# Findings of Fact | Site Plan Review

Property Address: 175 Fleet Street

Application #: LU-25-152

**RE: Request for Site Plan Review at 175 Fleet Street, Proposed Gilley's Addition**

**SITE PLAN**

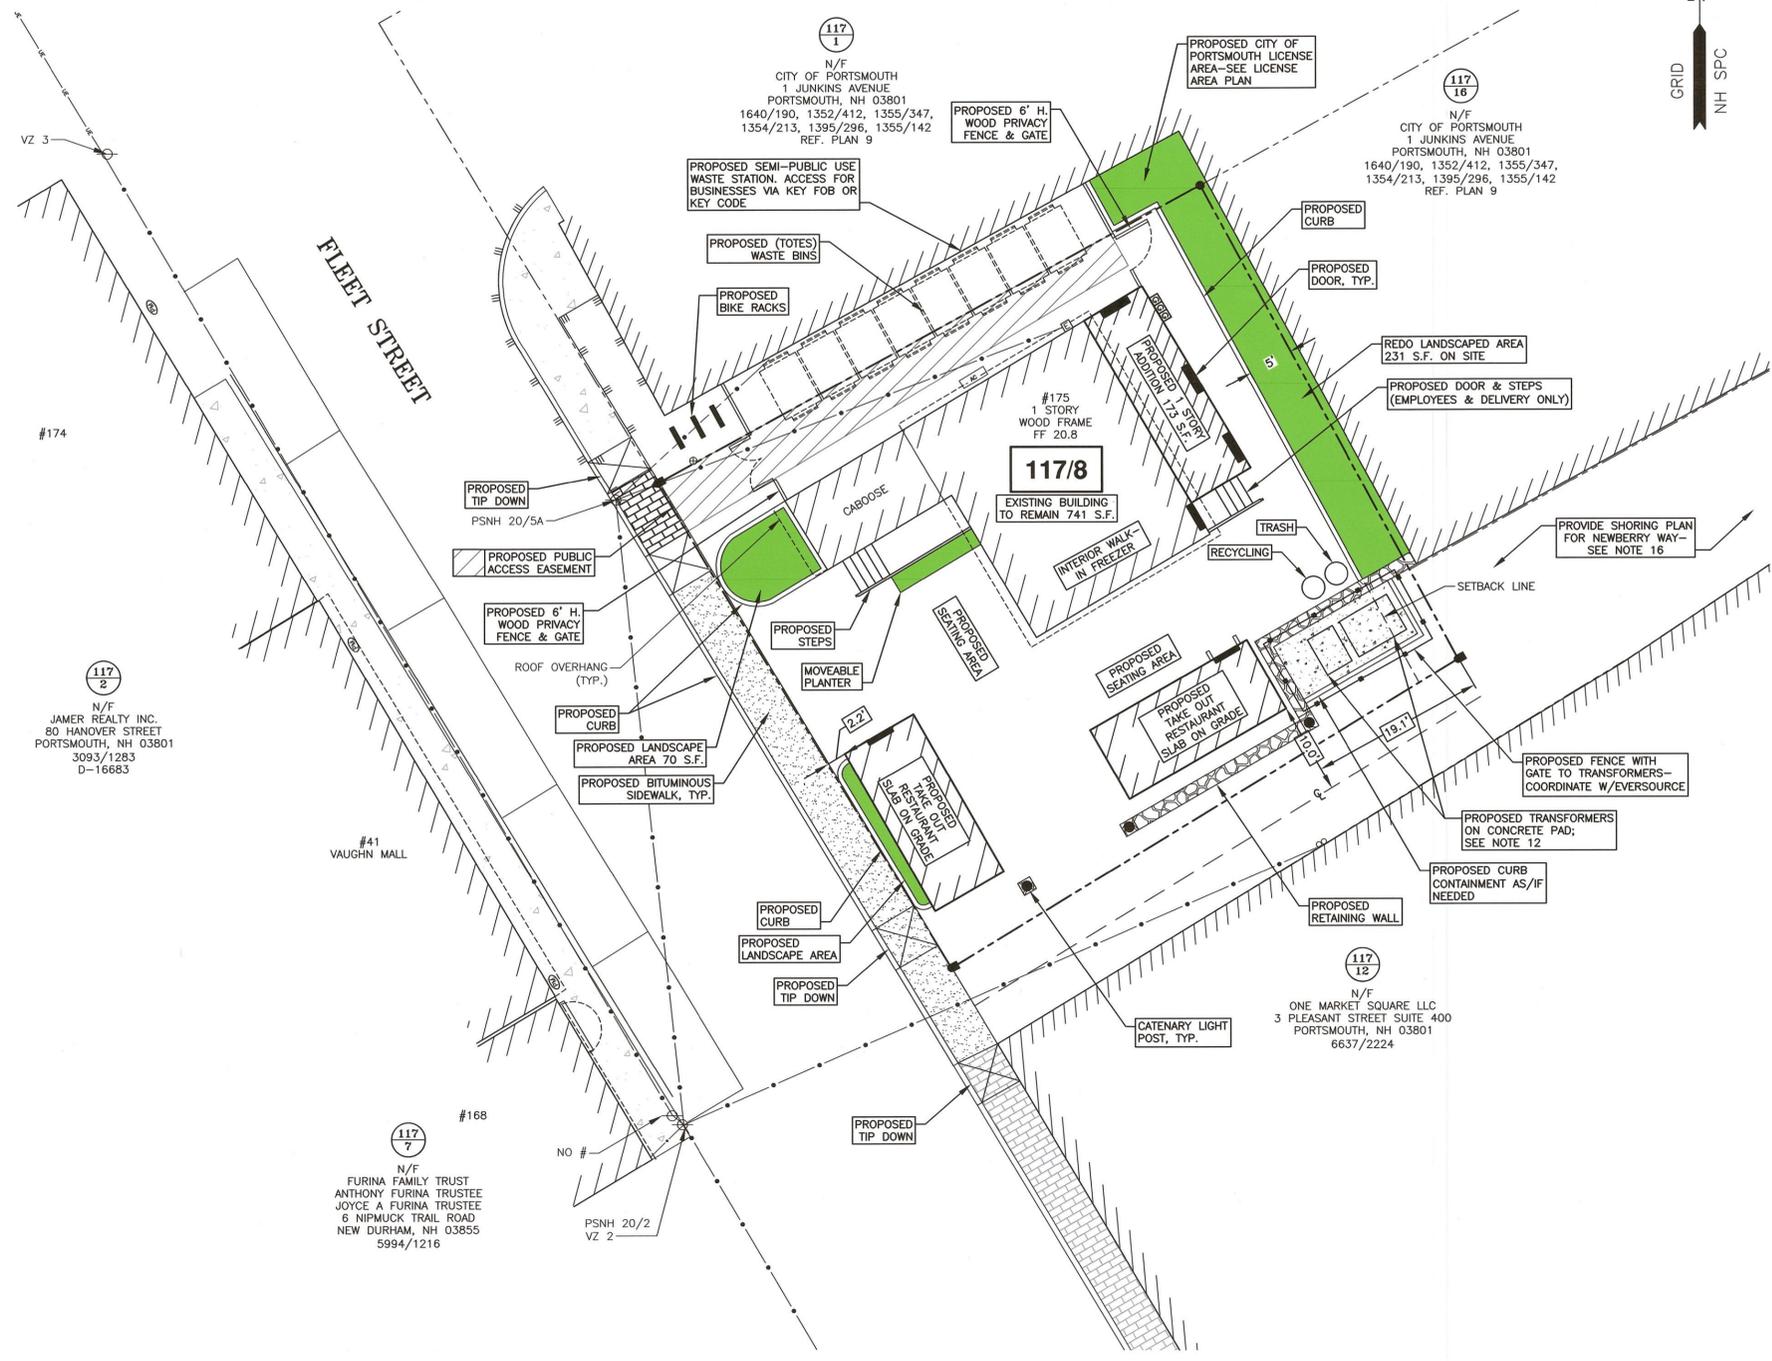
- 2) Please provide a green building statement. **The Green Building Statement is attached to this submission.**
- 3) The two kiosks will need to be individually licensed per health department requirements. **Plan Note 14 has been added to Site Plan Sheet C 201. The requirement would be appropriate as a condition of approval.**

- 4) Any fencing as required by the liquor commission or used to divide the site is required to go to the HDC. **Plan Note 15 has been added to Site Plan Sheet C 201. The requirement would be appropriate as a condition of approval.**

- 6) A shoring plan stamped by a structural engineer shall be provided to ensure there will be no undermining of any structure along Newbury Way. **Plan Note 16 has been added to Site Plan Sheet C 201. The requirement would be appropriate as a condition of approval.**

- A SHORING PLAN STAMPED BY A STRUCTURAL ENGINEER SHALL BE PROVIDED TO ENSURE THERE WILL BE NO UNDERMINING OF ANY STRUCTURE ALONG NEWBERRY WAY.
